**COMMISSION OF ARCHITECTURAL REVIEW  
STAFF REPORT  
October 24, 2017, Meeting**

10. **COA-024587-2017** (D. Perkins)

**2226 Monument Avenue  
Monument Avenue Old and Historic District**

**Construct a new front porch.**

2226 Monument Avenue (Richmond Assessor's Files 1934-1956)

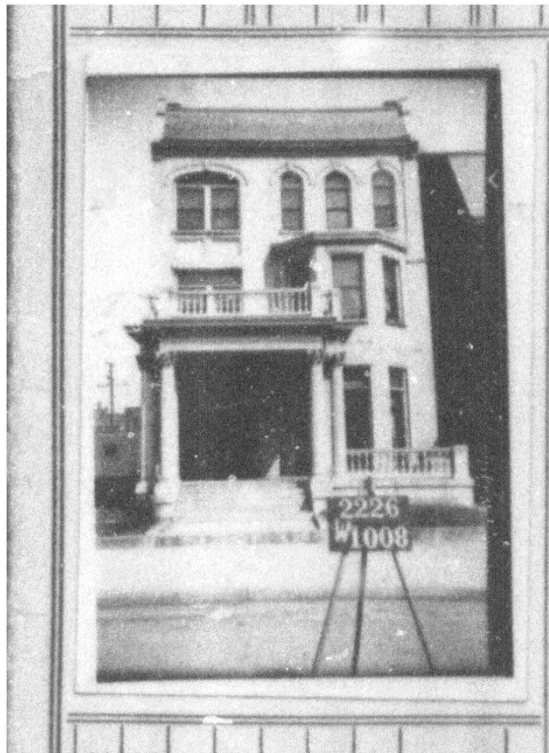
The applicant requests approval to construct a new front porch on a home in the Monument Avenue Old and Historic District. The existing home has a full façade first floor terrace. The applicant is proposing to construct a 2-story porch with round wood columns and a turned balustrade on the first and second story. The application notes that the project design is based on ghosting on the existing terrace as there is evidence of the former column locations. The front of the structure has been altered over time as the Sanborn maps indicate a smaller front porch that extended only to the projecting bay. Staff has located an image from the City Assessor's records which was taken between 1936 and 1953. The City Assessor's photograph shows the full façade terrace with a turned balustrade and a portico with a roof top balustrade and Corinthian columns. A post-1957 photograph from the Assessor's records shows the portico removed.

In 2005, the Commission approved a similar porch as the one proposed without the upper balustrade and with a copper roof with flat seams. During this previous review, the applicant noted that the structure was likely built with a small Romanesque porch which was later replaced with a full façade Georgian porch. No photographs or building plans were used to confirm the evolution of the porch structure during 2005 review.

**Staff recommends approval of the project with conditions.** The *Richmond Old and Historic Districts Handbook and Design Review Guidelines* note that when reconstructing a missing element; pictorial, historical, or physical documentation should be used as a basis for the design and materials (pg. 55, #7). As staff has located a photograph which shows an early and possibly the original porch at this structure, and there is physical evidence of the column locations; staff recommends the porch be reconstructed based on the photograph and physical evidence to include a portico and roof top and terrace balustrade rather than the full façade two story porch. Staff recommends revised plans which are consistent with the design, proportions, and details of the historic porch be submitted for administrative review and approval.
